APPEAL SUMMARY

Appeal ID: 16552

Project Address: 820 N Killingsworth St

Building/Business Name: Kanjay Building

PROPOSED CODE PLAN SITE PLAN
A003
PERMIT SET

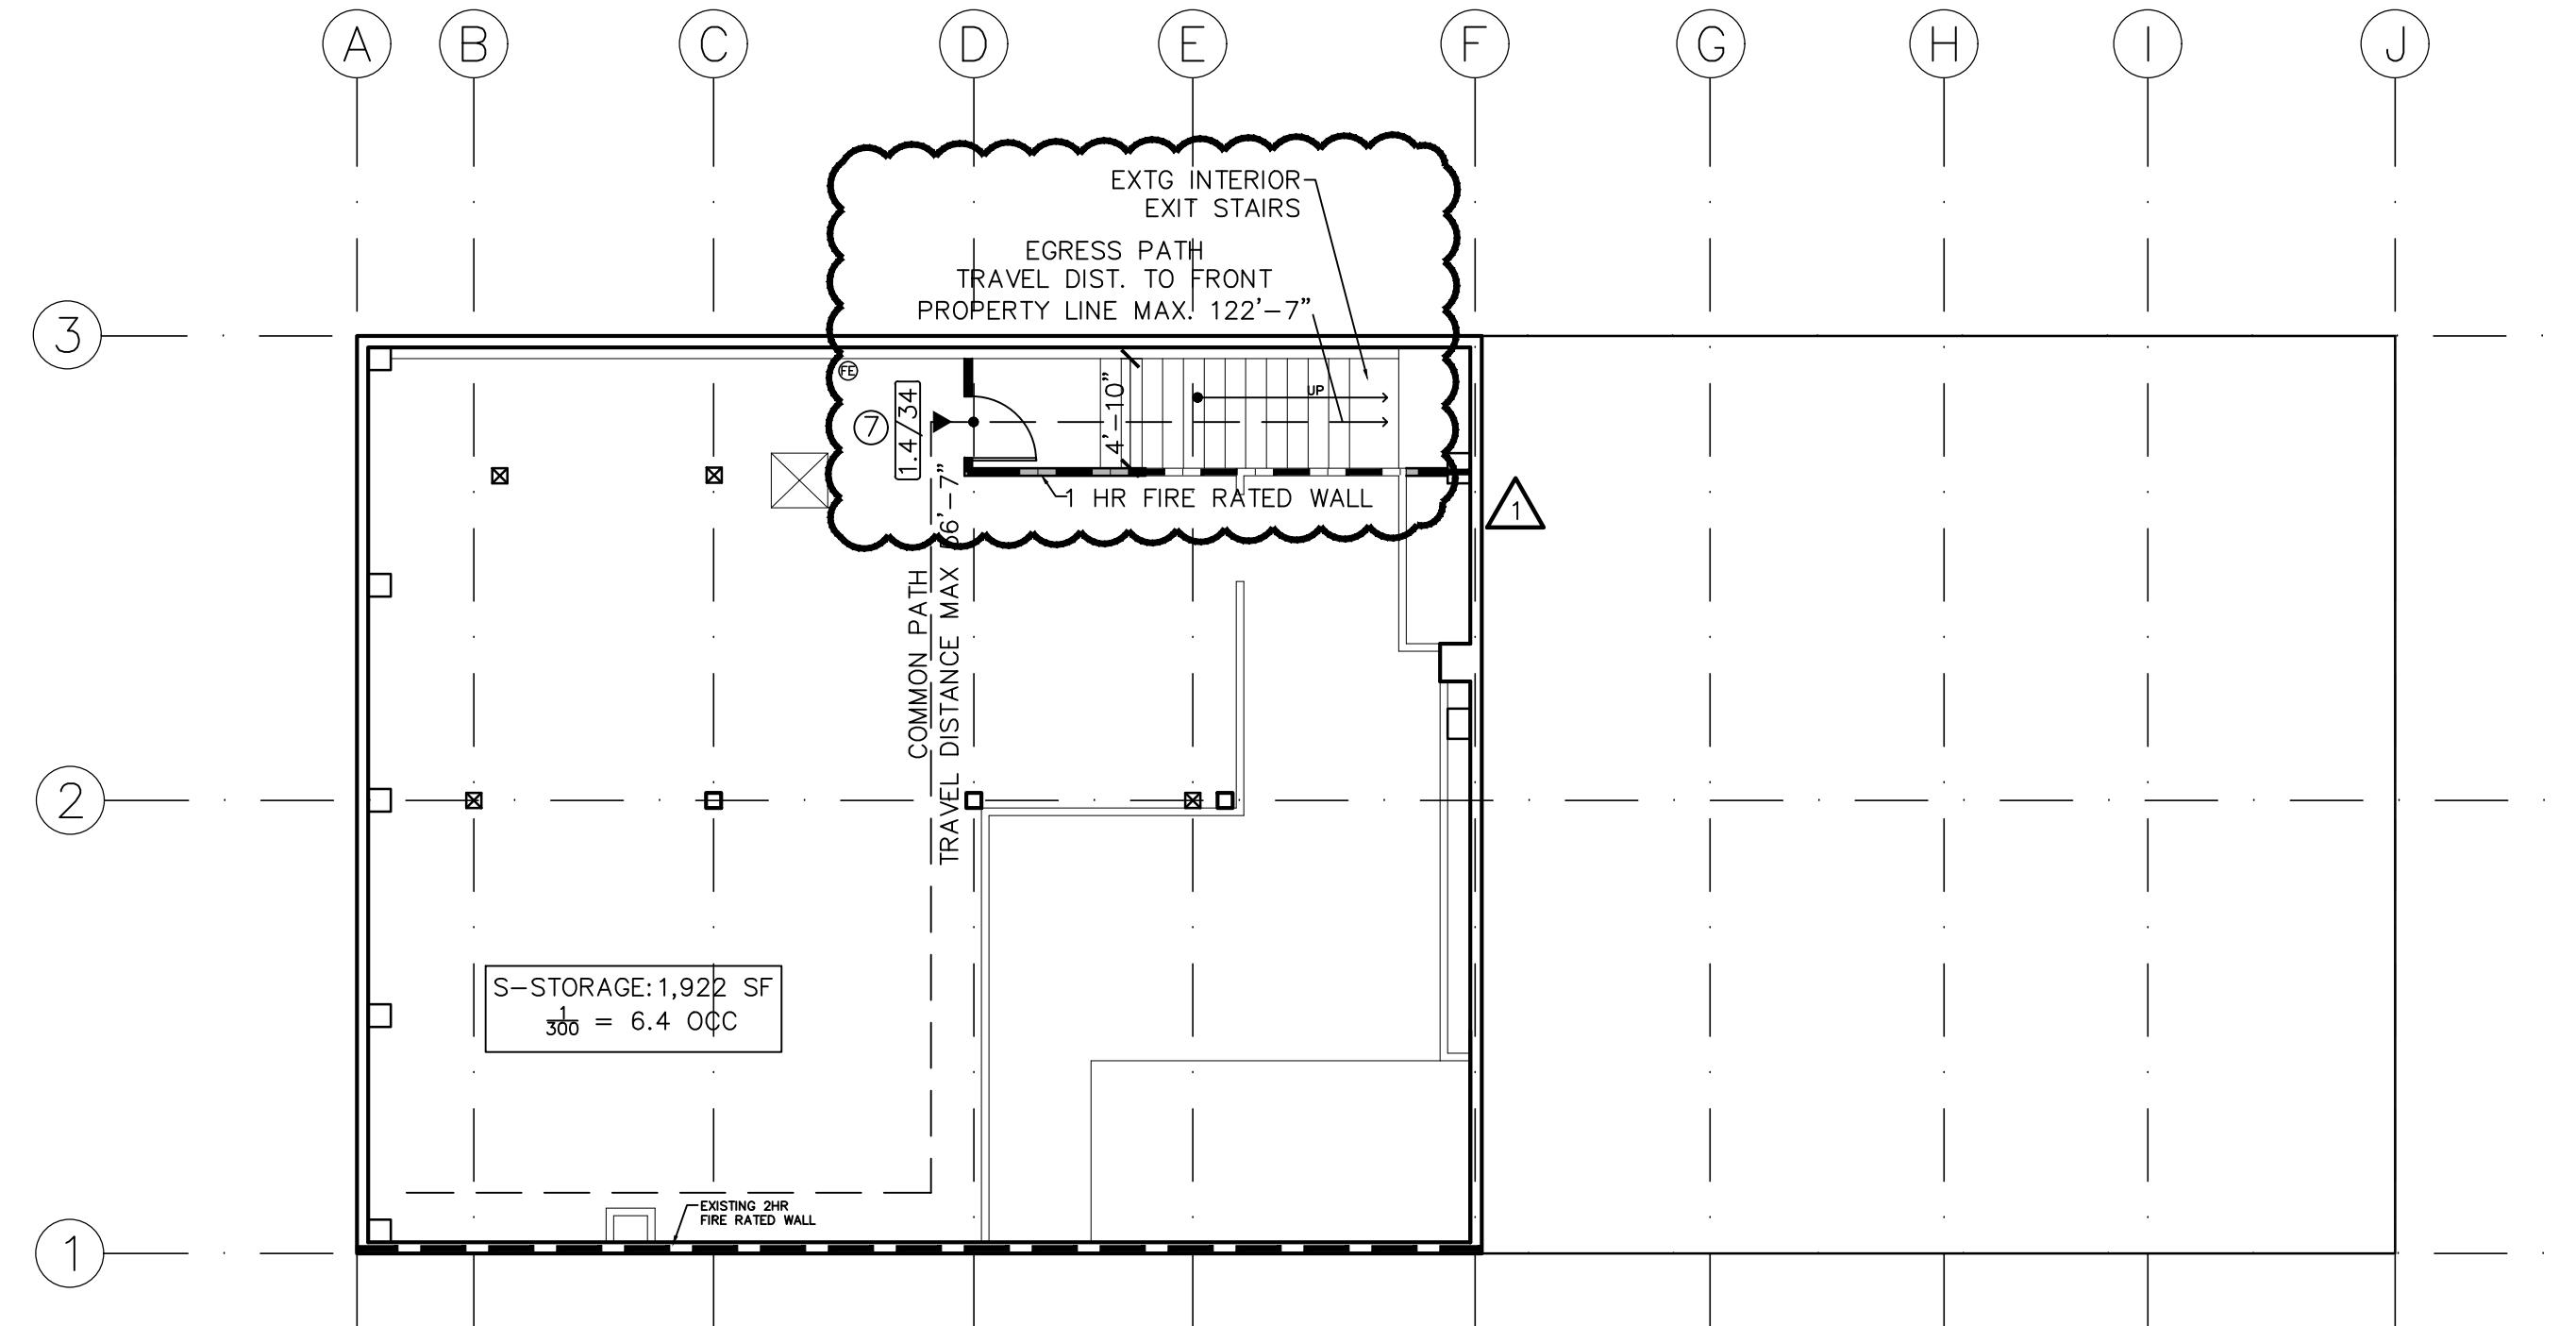
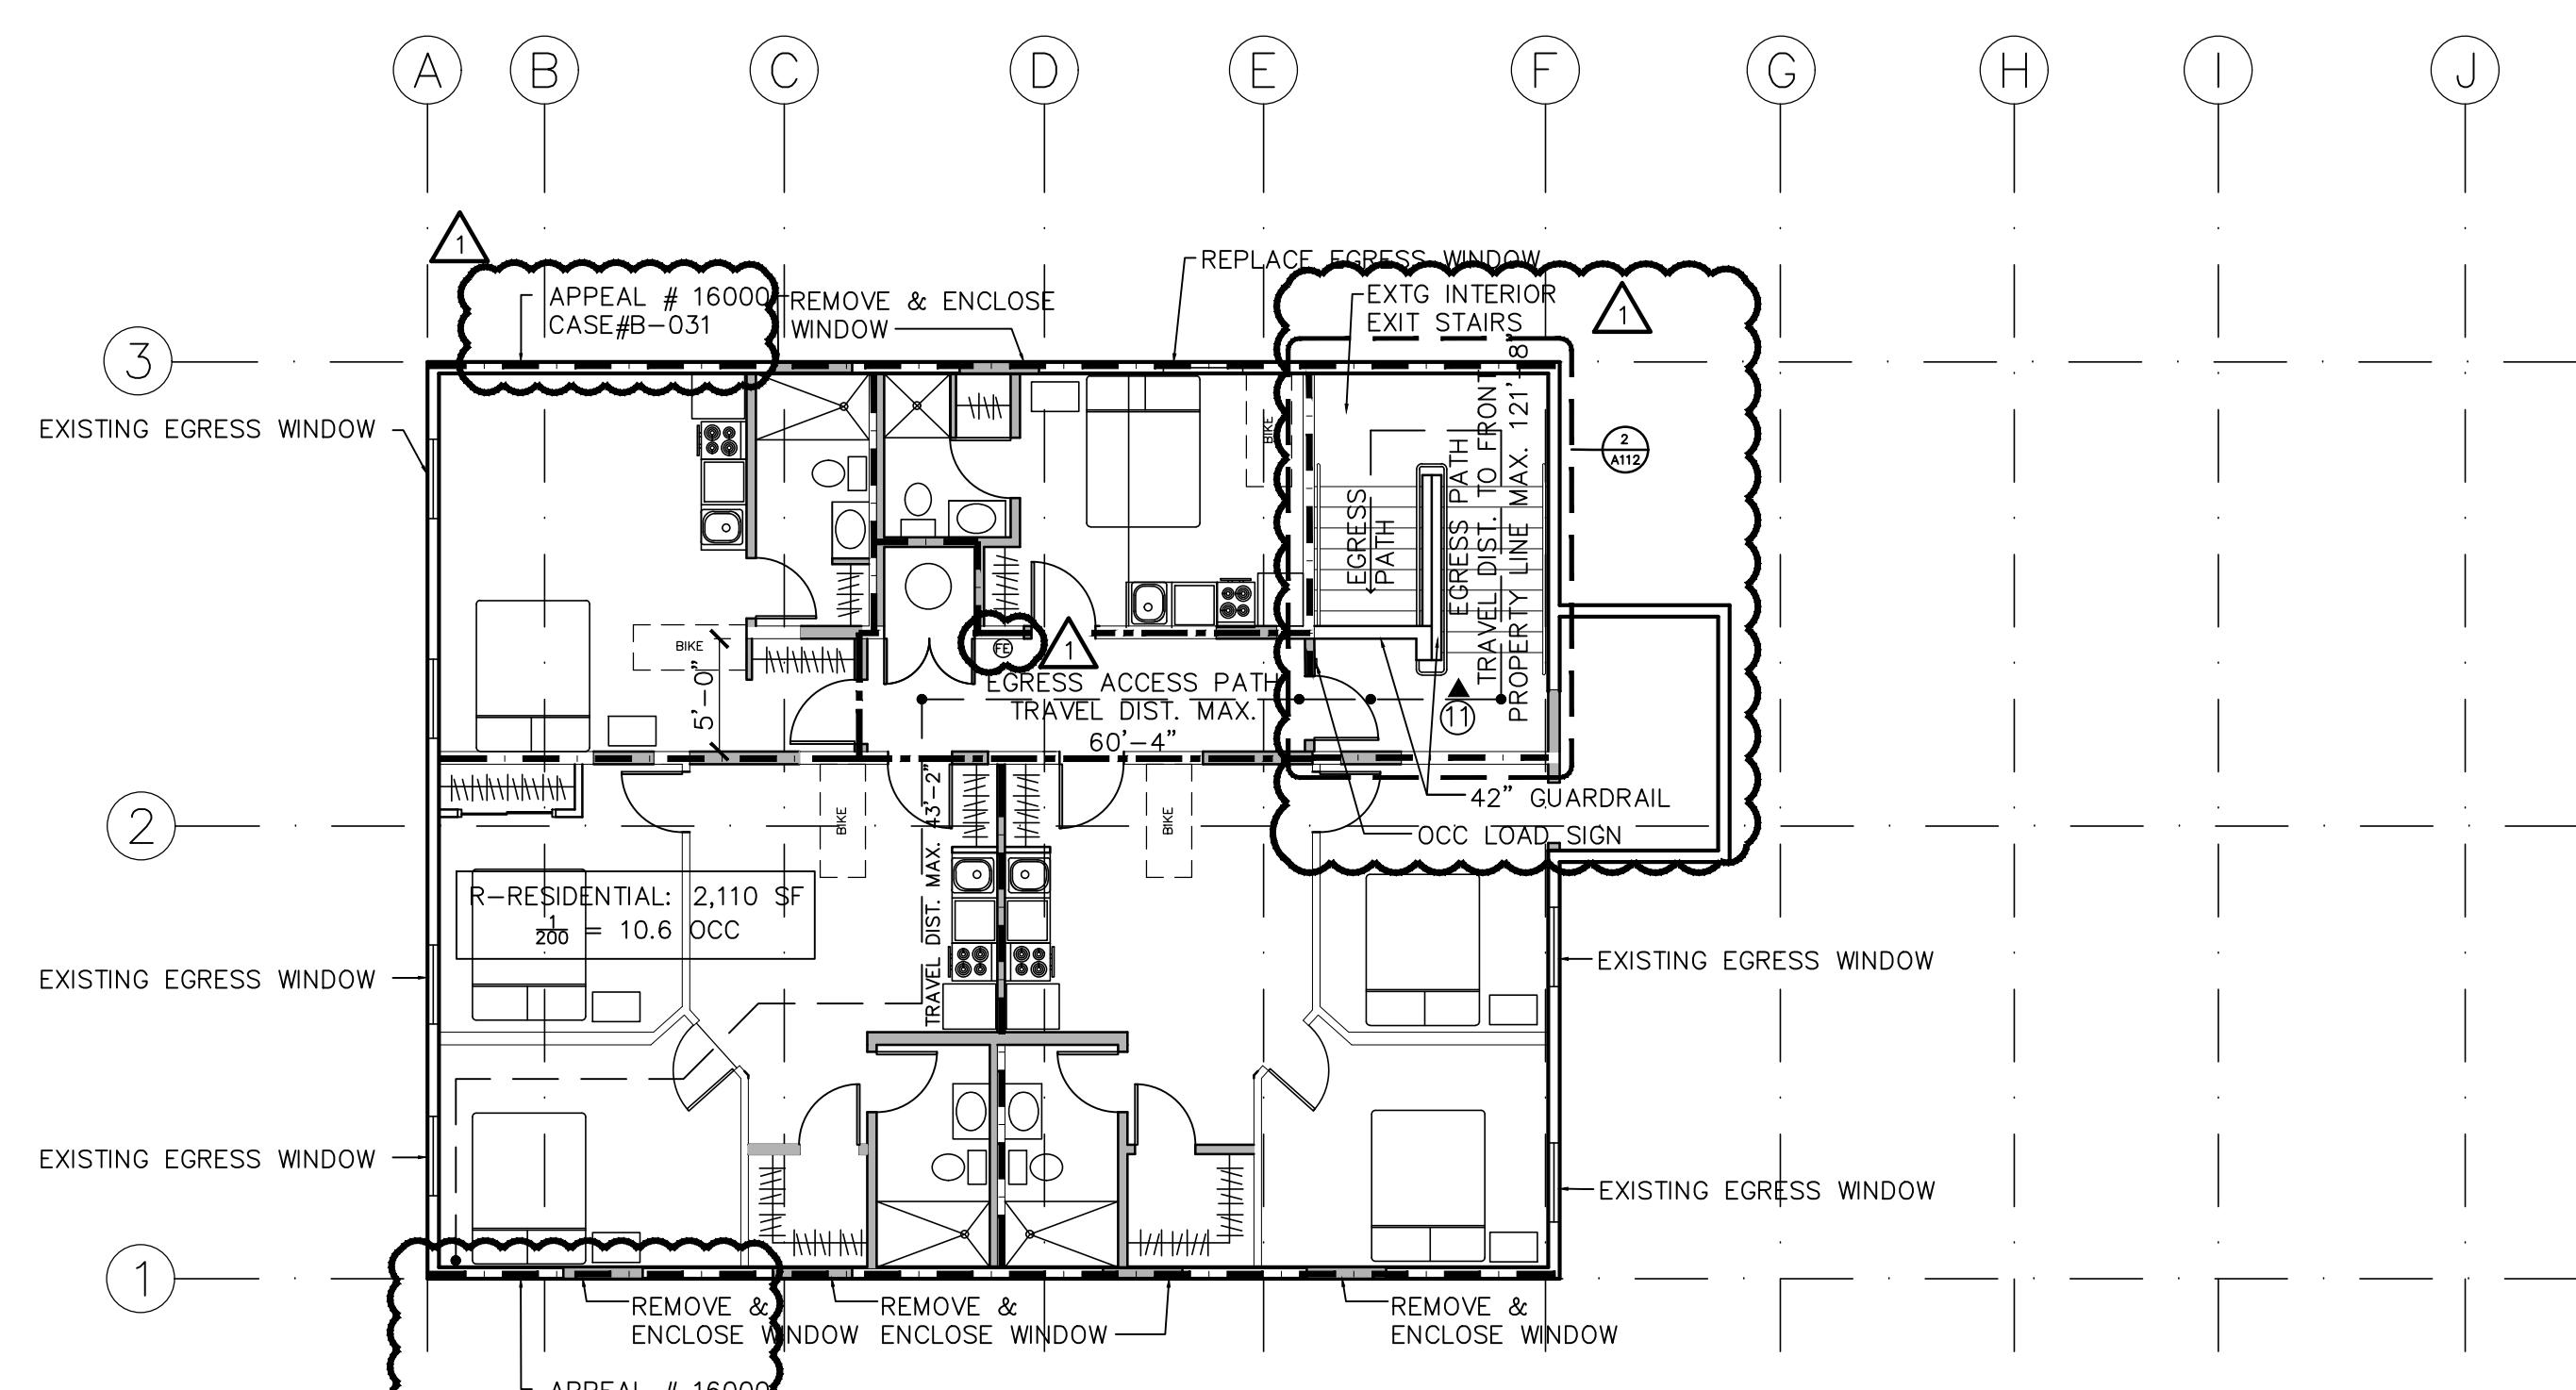
To relieve the building from the chapter 13 mandate and to bring the building into current compliance, we are providing 4 units a floor and updating the existing stair enclosure to an internal exit stair with access from a corridor system, we will sprinkler the building and provide appeals (appeal #16000)and updates for exterior property line walls and separation, this will bring the building into compliance with a 3-story residential occupancy with 1 exit.

We are proposing that the stair rise and run of 7.5" and 13" run be allowed to remain per chapter 34 and that the existing stairs remain in place while protecting the stairs in a code approved shaft. The existing stair width is above adequate, and the railing and guardrail will be brought to current code conformance. This gives equivalent protection to the stair and enclosures while allowing us

The current building condition and type does not comply with the current code without a sprinkler system. The building and height don't work with the VB designation that is the current stated building type. With sprinklers the building would be allowed under the type VB separated uses, with 4 units the building code would allow one exit. With sprinklers and a protected stair, the egress length is brought to current code.

Having the occupancy updated to have a code allowed single egress in a protected shaft increases safety over the current open stair enclosure and fire escape egress. Currently multiple rooms egress over the adjacent roof of the neighboring property. That condition would be alleviated by reducing the unit number and creating bedrooms that face egress windows. Interior wall ratings and corridor ratings for fire protection would be brought up to current code and current UL listings.

1. Removal from Chapter 13 status: Hold for additional information.
